BELLEFONTE COMBINED LICENSE APPLICATION – RESPONSE TO REQUEST FOR
ADDITIONAL INFORMATION – BASIC GEOLOGIC AND SEISMIC INFORMATION

Reference: Letter from Joseph Sebrosky (NRC) to Andrea L. Sterdis (TVA), Request for
Additional Information Letter No. 123 Related to SRP Section 02.05.01 for the
Bellefonte Units 3 and 4 Combined License Application, dated September 4, 2008

Responses to NRC Request for Additional Information letter No. 123 dated September 4, 2008
(10 pages, including this list)

Subject: Basic geologic and seismic information in the Final Safety Analysis Report

BLN COL 2.5-1 **Soil Weathering Features in Pleistocene Terrace Deposits near Gadsden, Alabama** **FIGURE 2.5-209**

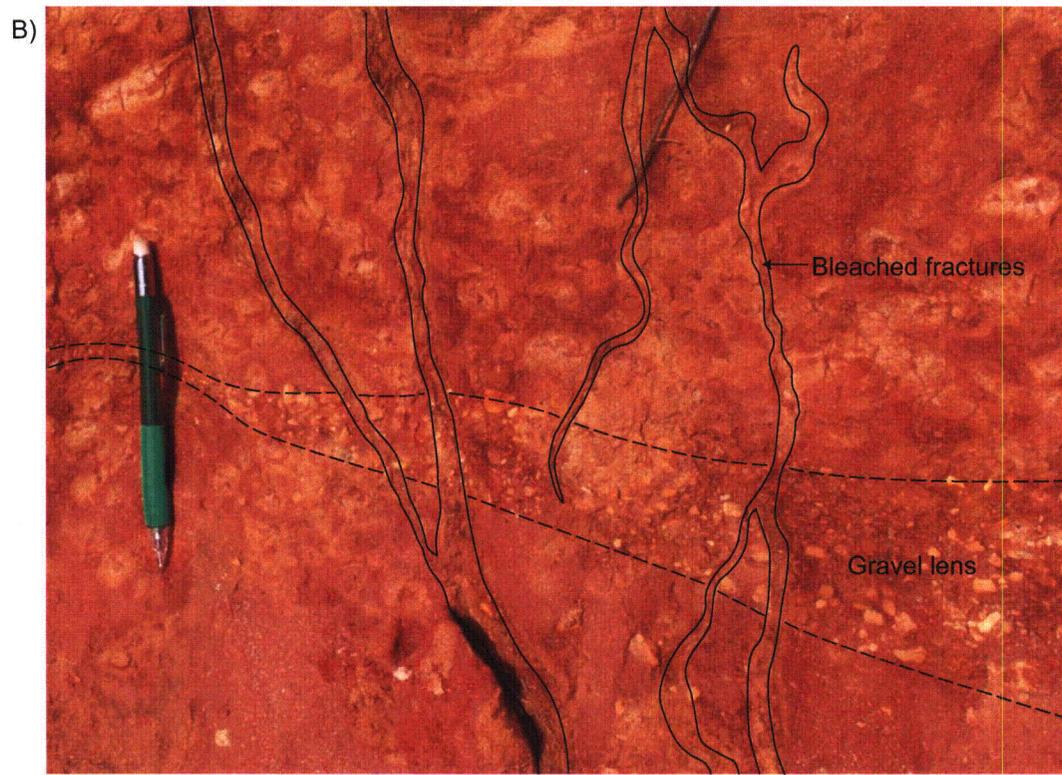
FSAR 2.5.1.1.3.2 describes sub-vertical, upward-widening features in a soil exposure and states that they “resemble non-tectonic soil weathering features (cutans)” Please present observations, measurements, or analyses, and figures, photographs, or other illustrations that demonstrate whether or not these features could be seismically induced.

The sub-vertical features are found in the iron-rich horizons of the western and central cut faces, in either the mottled or unmottled horizons. The features appear as sub-vertical veins 0.5 to 2 in. wide, lighter in color than the surrounding soil matrix (FSAR Figure 2.5-209 panels a and b). They are similar to the light colored mottles within the iron-cemented horizon. The veins are seen to occasionally branch upward or downward, and may be part of a group of parallel veins. Vein width is fairly constant with depth, though examples can be found that pinch out with depth or widen near the surface. Some end abruptly at a bedding contact. The edges of the veins are typically lined with reddish iron cementation.

The veins pass through stratigraphic contacts without offsetting or disturbing them. FSAR Figure 2.5-209 Panel A shows several veins passing through a gravel lens bounded by mottled silty clay loam. The gravel is not displaced, and gravel clasts occur within the vein where it passes through the lens.

A new Figure 2.5-209, Soil Weathering Features in Pleistocene Terrace Deposits, Gadsden, Alabama, is added (Attachment 2.5.1-01A).

At an exposure of these high terrace deposits in Gadsden (Field Stop KH9, Figure 2.5-208a) distinct subvertical veins, 0.5 to 2 inches wide, of light brownish gray material, were observed within the yellowish red soil of these old deposits (Figure 2.5-209 panel a). The veins could be traced through a strongly mottled horizon (typically 3 to 5 feet below the surface), through the underlying unmottled partially iron-cemented sediments, to the base of the exposure 6 to 8 feet below the surface. The veins become less distinct in the upper part of the mottled horizon and could not be traced into the upper 0.6 m (2 ft.) of the soil. The veins are seen to occasionally branch upward or downward, and may be part of a group of parallel veins. Vein width is fairly constant with depth, though examples can be found that pinch out with depth or widen near the surface. The edges of the veins are typically lined with reddish iron cementation.

The veins pass through stratigraphic contacts without offsetting or disturbing them. Figure 2.5-209 panel b shows several veins passing through a gravel lens bounded by mottled silty clay loam. The gravel is not displaced, and gravel clasts occur within the vein where it passes through the lens.

FIGURE 1
 Location Uncertainty of Seismicity

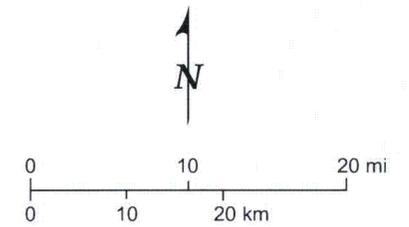
Given the uncertainty in locating earthquakes in most network data, especially at distances corresponding to the Eastern Tennessee Seismic Network stations, distance to the nearest station, station density, crustal velocity structure and etc., please discuss the likelihood that some of the earthquakes are located on one or more of the mapped faults shown in FSAR Figures 2.5-294 and 2.5-220.

Figure 1 (Attachment 02.05.01-03A) shows the projections of the 68% hypocenter error ellipsoids in the horizontal plane for instrumentally located earthquakes in the site vicinity. The data are taken from the Southeastern United States Seismic Network Bulletins, 1973-2006 (Reference 3). Most earthquakes within 25 km of the site are located to the northwest of the surface trace of the Sequatchie Valley thrust, of Late Paleozoic age, which dips to the southeast. Figure 1 shows that the epicenter semi-major error ellipse axes (68% confidence) are on the order of 2 km or less for most of these events, suggesting that they are determined with sufficient accuracy to support the interpretation that the majority occurred to the northwest of the Sequatchie Valley fault and therefore, have no relation to that feature.

FIGURE 1
 Location of Wells (red dots) and Seismic Reflection Profiles (wide gray lines), Used to Constrain the Structure of the Appalachian Thrust Belt. Thomas and Bayona (2005) Combine These Data with Geologic Mapping to Create 18 Structural Cross Sections (Numbered Green Lines)

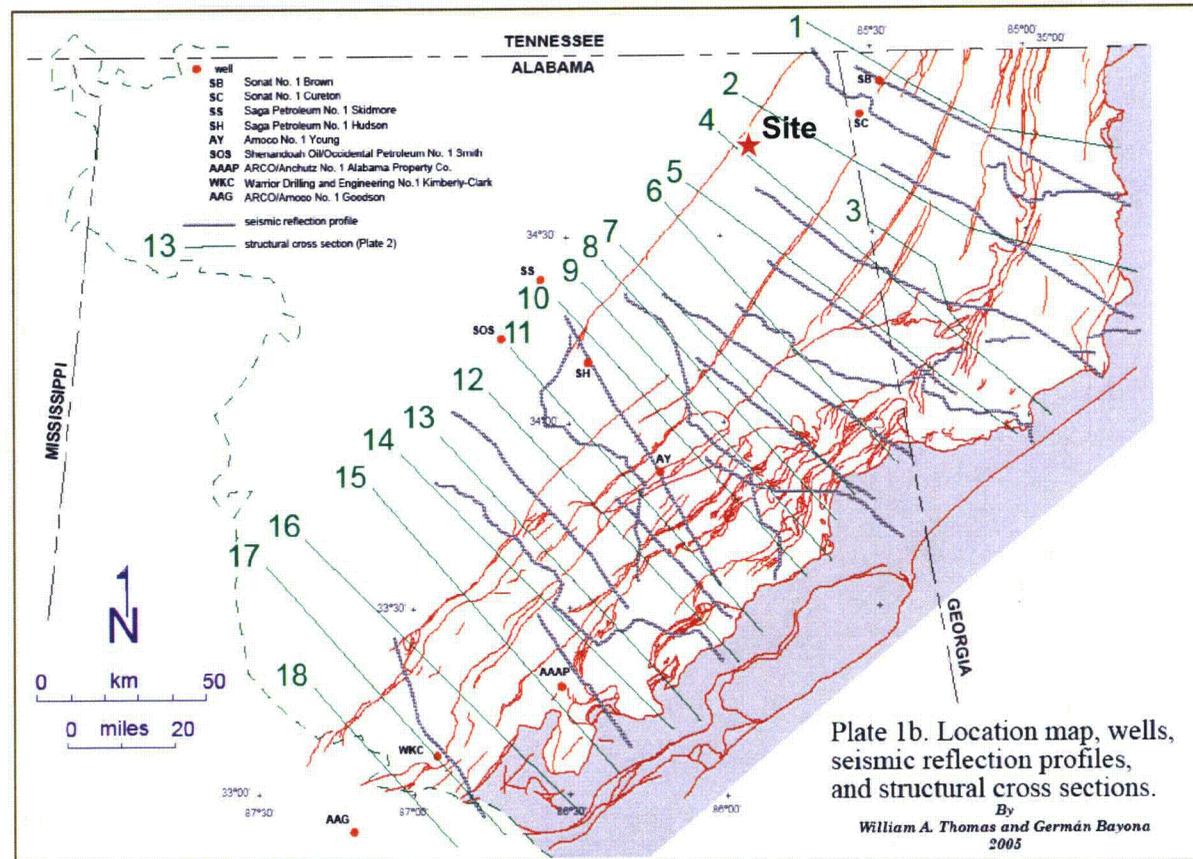
Please provide evidence that all of the thrust faults shown in FSAR Figure 2.5-294 near the Bellefonte COL site sole out into the Appalachian detachment. Figure 2.5-220 shows subbasement faults with the same general northeast-strike and similar locations as those of Fig. 2.5-294. Given fault location uncertainty, explain whether or not some of the faults shown on these two figures could be the same fault penetrating through the detachment.

The seismic reflection and well data used in these studies were generally collected by the petroleum industry. Eighteen parallel seismic reflection profiles, each approximately 50 miles long, cross the thrust belt and four deep wells penetrate the basement (Figure 1 of Attachment 02.05.01-04A). Geologic mapping of the Paleozoic rocks was conducted by a variety of researchers including the authors.
